PROPOSED TECHNICAL SPECIFICATION CHANGES
RELATED TO NUREG-0737 ITEMS

NEW YORK POWER AUTHORITY
JAMES A. FITZPATRICK NUCLEAR POWER PLANT
DOCKET NO. 50-333

ATTACHMENT II

FIGURE 6.2-1

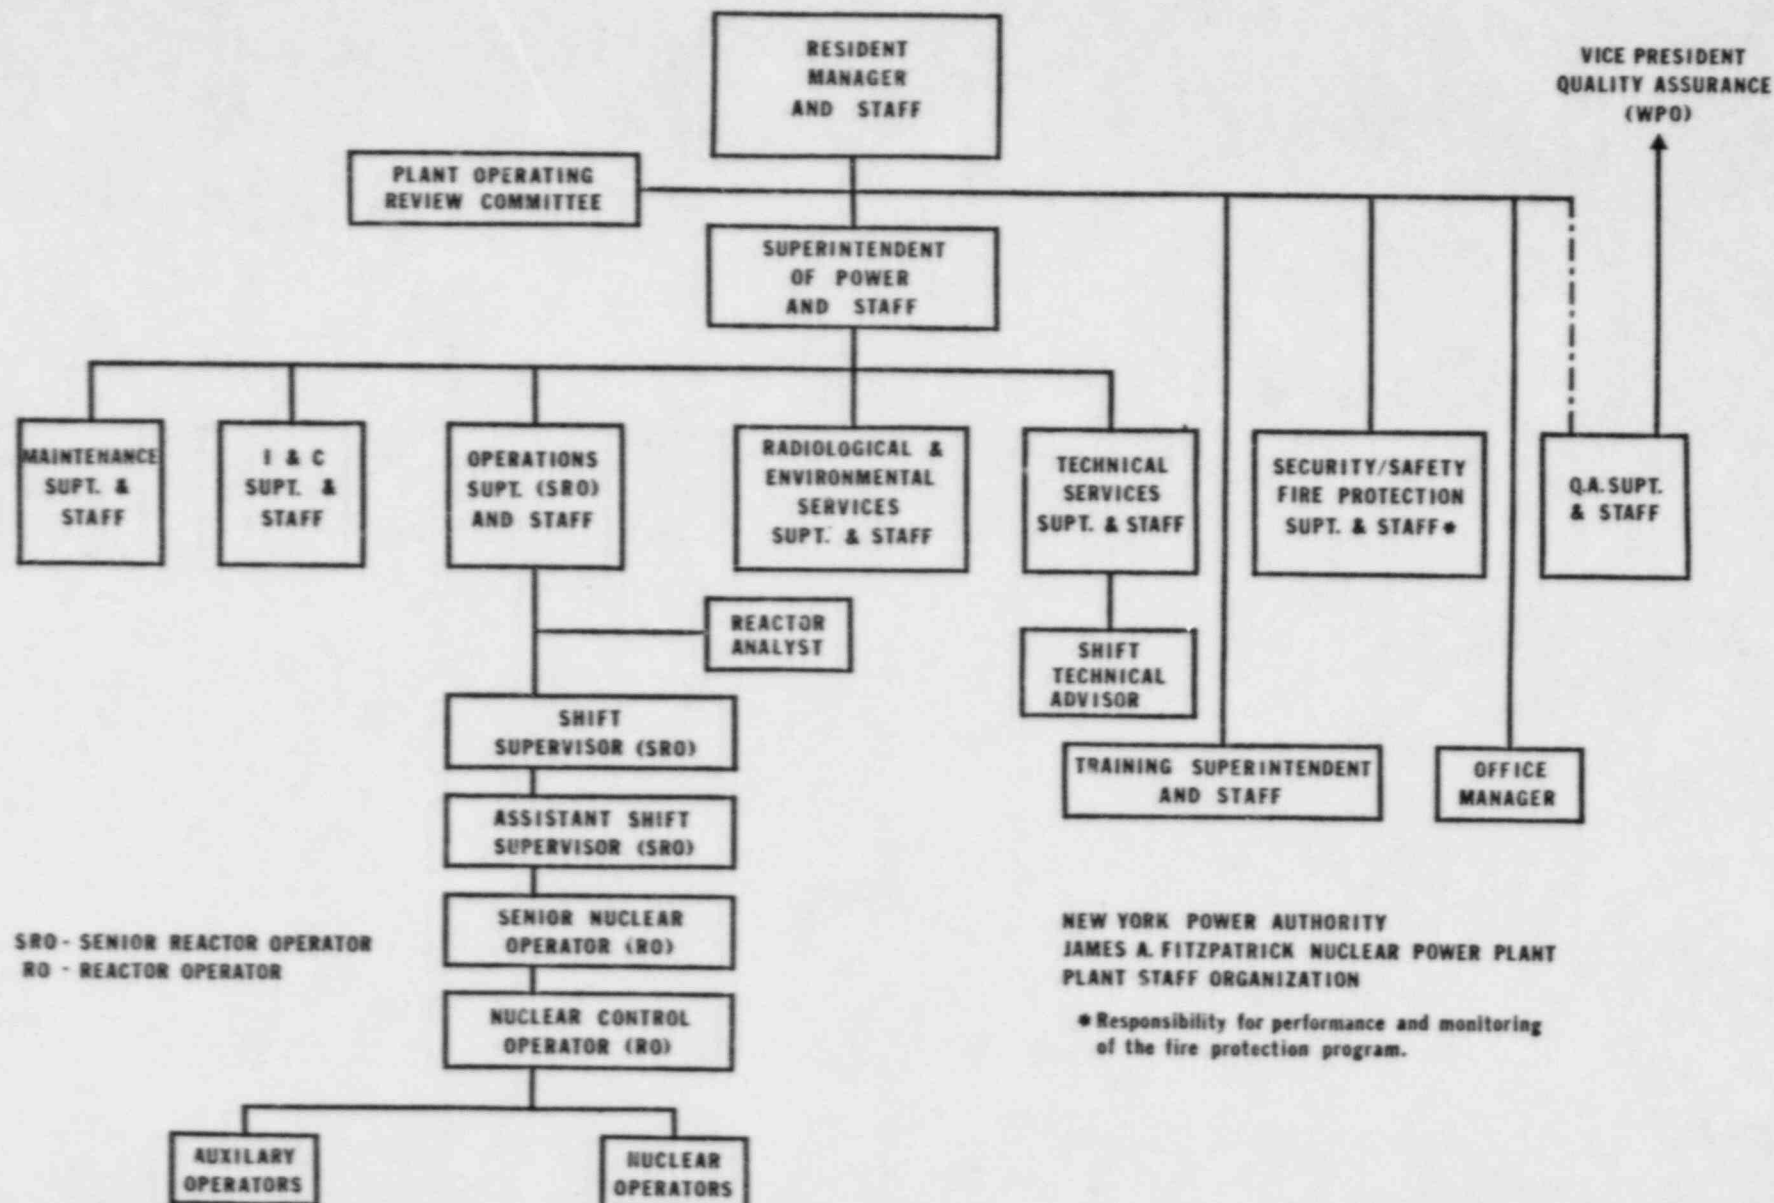
On page 260, "Asst. Shift Supervisor" is added to Fig. 6.2-1, and "Vice President Quality Assurance (NYO)" is changed to "Vice President Quality Assurance (WFO)."

The proposed change to Figure 6.2-1 on page 260 is needed to be consistent with NUREG-0737 Item I.A.1.3.2., "Shift Manning". The proposed change is considered to match Commission example (vii).
